# Staff Report

## Site Plan Review

Files: SP-28-19 & FP-09-19

Proposal:	Site Plan Review and Floodplain Development Review to construct a 264-unit apartment complex (Brandis Meadows Apartments) with associated parking and common open space.
Review Body:	Staff (Type I-L review)
Report Prepared By:	Laura LaRoque, Senior Planner

**SITE OVERVIEW PLAN**

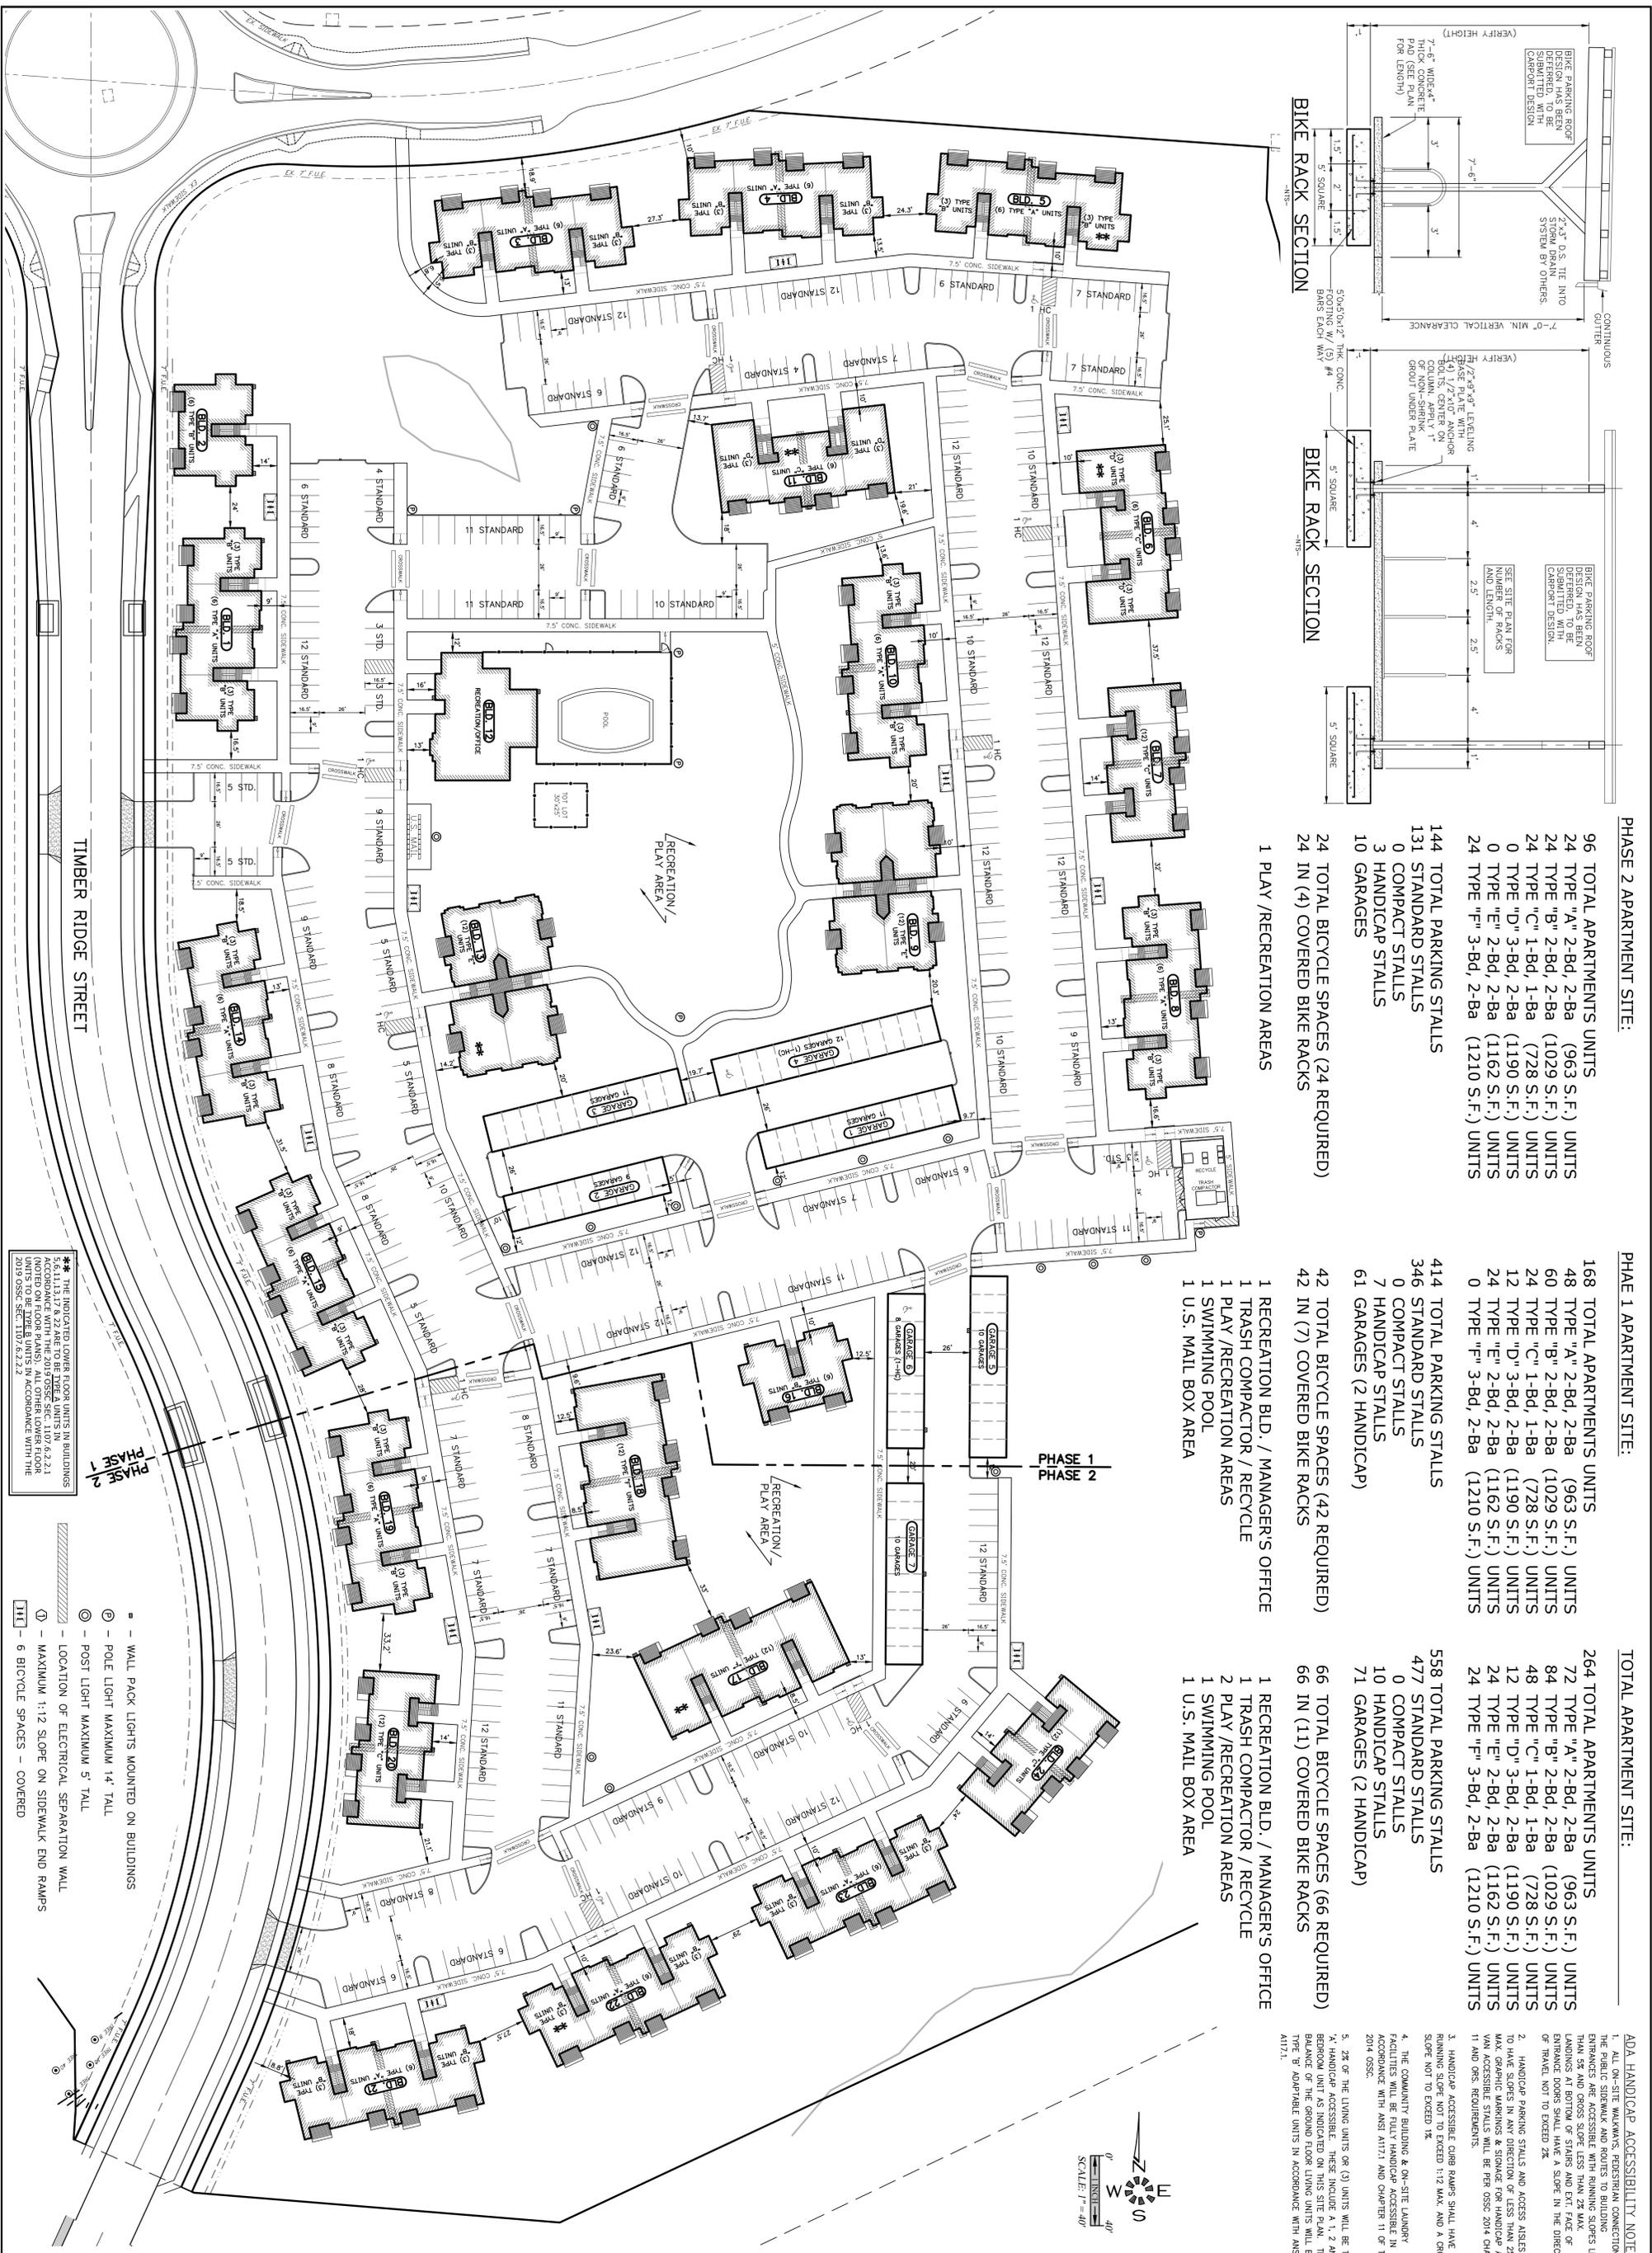
- 3.2 As shown on the Site Overview Plan (Attachment B.1, Sheet SDR07), Timber Ridge Street is proposed to run north-south along the west of the site from the roundabout at Knox Butte Road to Burkhardt Creek.

Setbacks. In the MUC zoning district, the minimum and maximum setback from a front property line is 5 feet and 25 feet, respectively. The Site Overview Plan shows Buildings 3 - 5 setback from the (front) property line at Knox Butte Road 16.7 feet to 25 feet, and Buildings 1 - 2, 14 - 15, and 19 - 21 from the (front) property line at Timber Ridge Street 7 feet to 20 feet (Attachment B.1, Sheet SDR07).

Lot Coverage. The maximum lot coverage in the MUC zoning district is 80 percent. The total site area is 16.52 acres (719,698 square feet) in size. The Site Overview Plan (Attachment B.1, Sheet SDR07) shows the total proposed developable area is 13.23 acres (576,272 square feet), which includes landscaped areas, or 80 percent of the total site area.

6.5 Article 6 Natural Resource Overlays: The location map (Attachment A), shows Significant Wetland (/SW) and Riparian Corridor (/RC) overlays are located around the periphery of the site. The Site Overview Plan (Attachment B.1, Sheet SDR07) shows that these natural resource overlays are not impacted; therefore, a natural resource impact review and mitigation plan are not necessary for the proposed project.

**GRADING & DRAINAGE PLAN - NORTH**

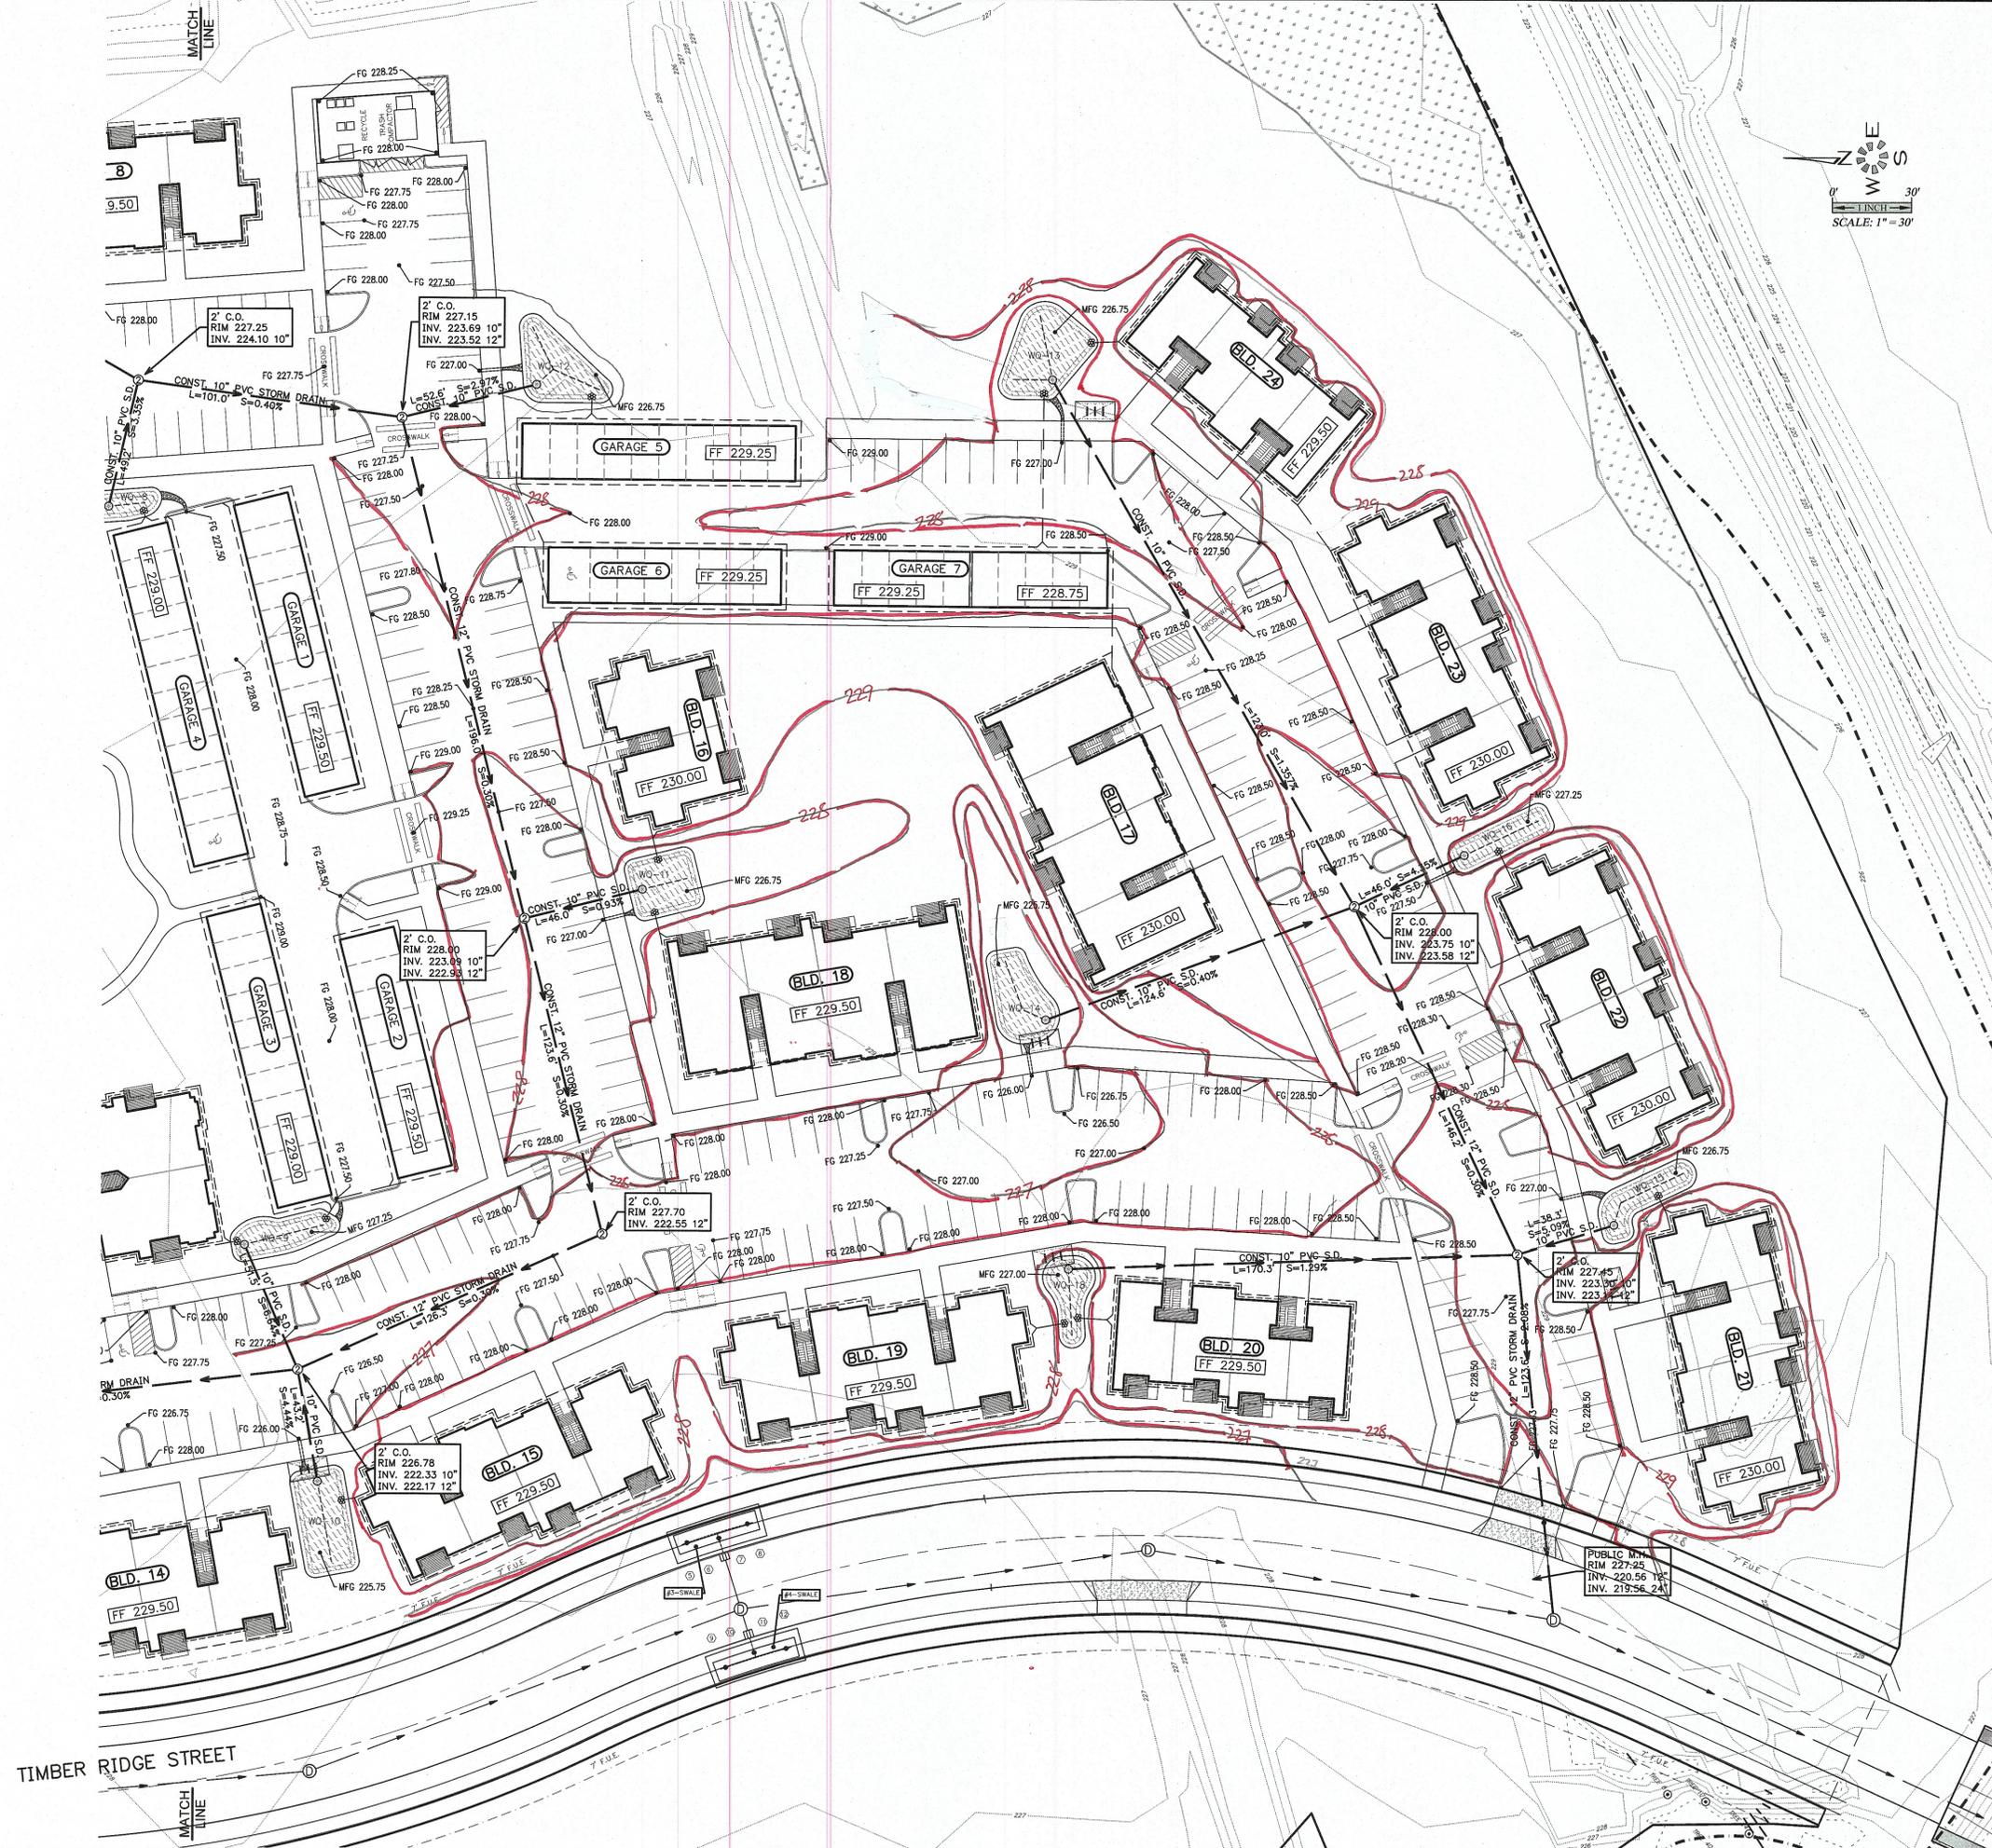
Based on the materials provided by the applicant, no grading is proposed within the mapped SFHA (one percent annual chance floodplain). As shown on Attachments B.27 and B.28 (Grading Plan Sheets SDR10 & 11), the building finished floor elevations are generally three feet or more above the BFE (at 229.50 feet). Since all proposed activities are outside the mapped SFHA, ADC 6.100 *Floodway Restrictions*, ADC 6.101 *Alteration of a Watercourse*, and ADC 6.111 *Grading, Fill, Excavation and Paving* do not apply at this time.

**STREET IMPROVEMENT  
 PLAN - TIMBER RIDGE  
 STREET**

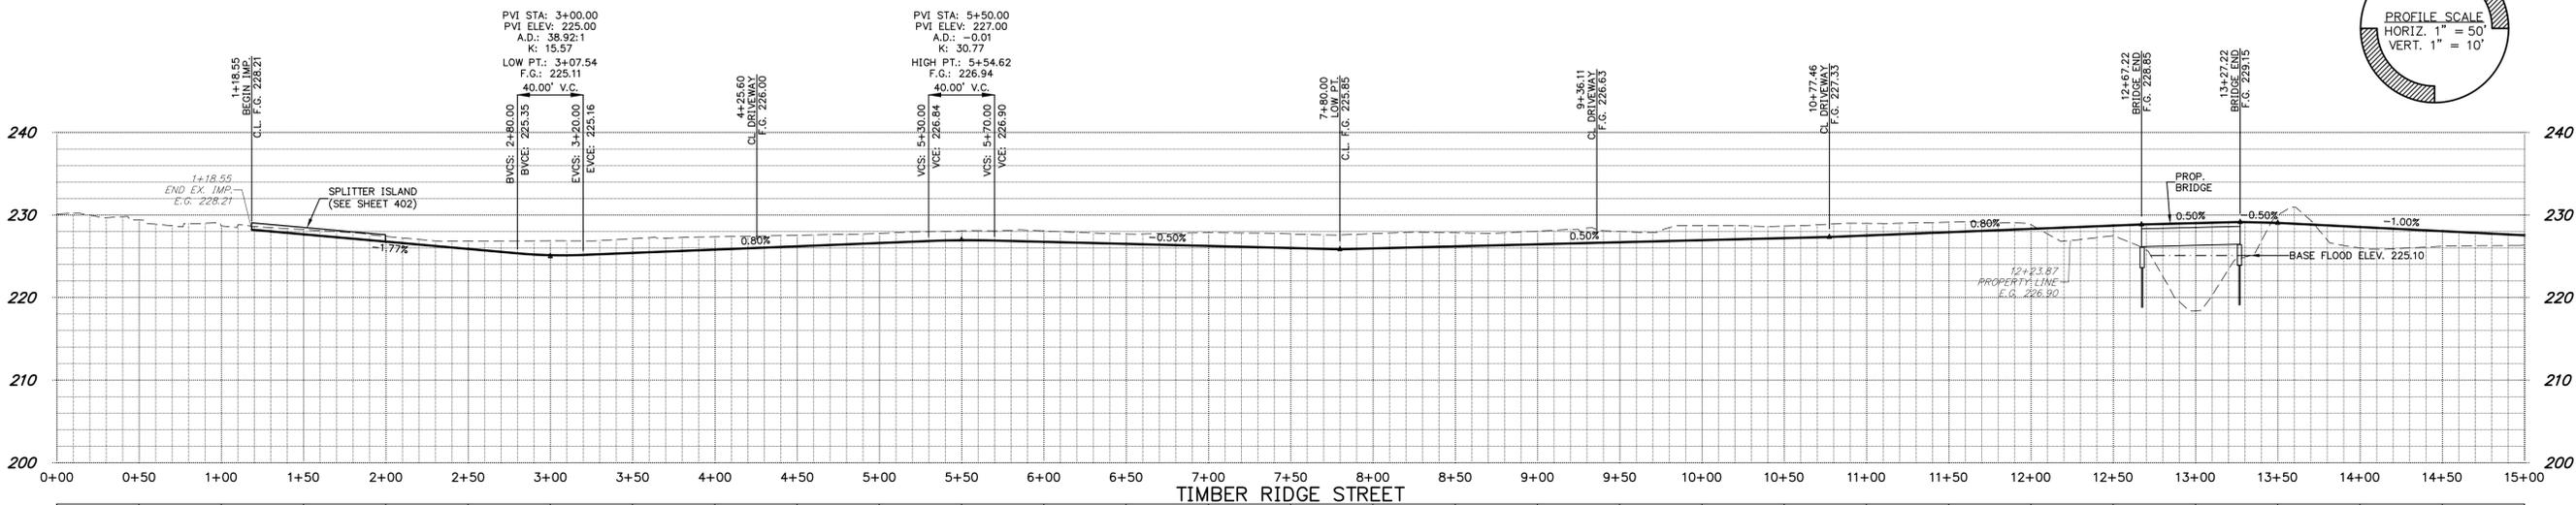
6.1 The proposal will improve Timber Ridge Street, which runs north to south through the site. A Site Improvement (SI) Permit (file SI-20-17) was submitted by the applicant to the Albany Public Works Department. Street Improvement Plan Sheet 401 (Attachment B.29) shows the crown elevation of Timber Ridge Street at its lowest point is 225.11 feet. The Base Flood Map (Attachment B.25, Sheet SD04) shows the BFE at its highest point to be 226.06 feet. Based on this information, the crown elevation of Timber Ridge Street will not be lower than one foot below the BFE.
